SERVICE BULLETIN

RIDES: SIZZLER, SUPER SIZZLER, AND DELUXE SIZZLER

SUBJECT: INSTALLATION OF SEAT BELTS

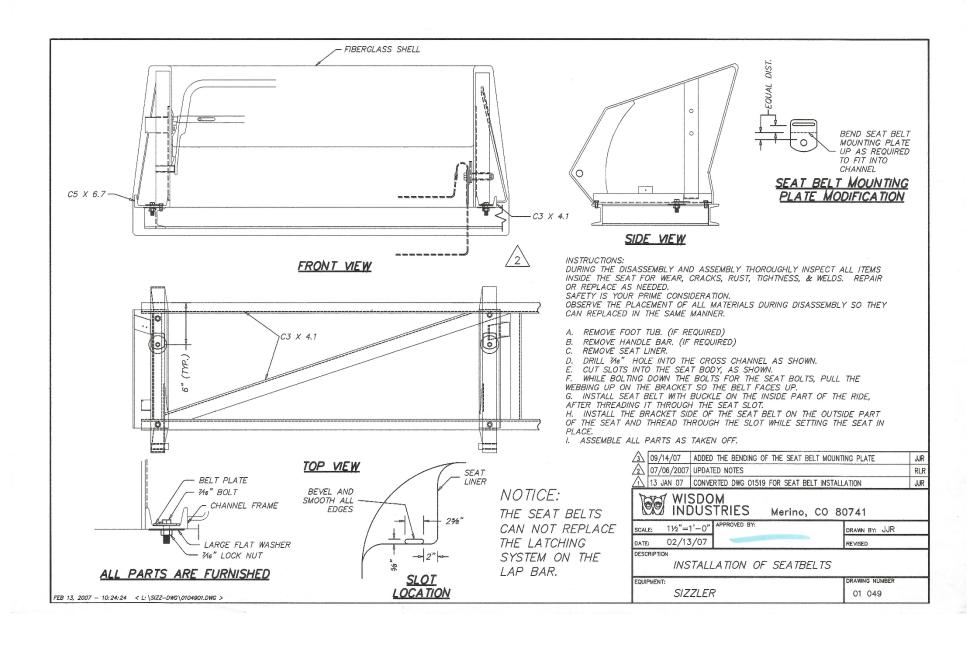
It is now <u>mandatory</u> that SEAT BELTS be installed on all Sizzler, Super Sizzler, and Deluxe Sizzler rides.

Due to exposure to dirt, weather, moisture and debris, the latching mechanisms must be checked daily to ensure proper operation.

- 1. Remove seat liner and quarter panel.
- 2. Drill a 7/16 inch diameter hole in each seat iron lower channel. (Refer to attached drawing.
- 3. Bolt the seat belt mounting bracket for the buckle end of the belt to the outside seat iron using one 7/16 inch diameter grade 5 bolt and locknut.

- 4. Cut a 1/2 inch high by 2 inch wide slot at the lower back corner of the large seat liner section.
- 5. Slide the seat belt bracket for the tongue end of the belt into the slot and bolt to the seat iron using a 7/16 inch grade 5 bolt and locknut.

- 6. Install the large section of seat liner using 3/16 pop rivets or threaded fasteners into the seat.
 - ► NOTE: Make sure that the seat belt is not pinched or cut during the installation.

- 7. Install the quarter panel section of the seat liner into place. Notchthe corner where the seat belt pulls through the gap between the two seat liner pieces.

- 8. Round any edges that may cut the belt.
- 9. Install the seat lock brass.
- 10. Test the seat lock for proper operation.
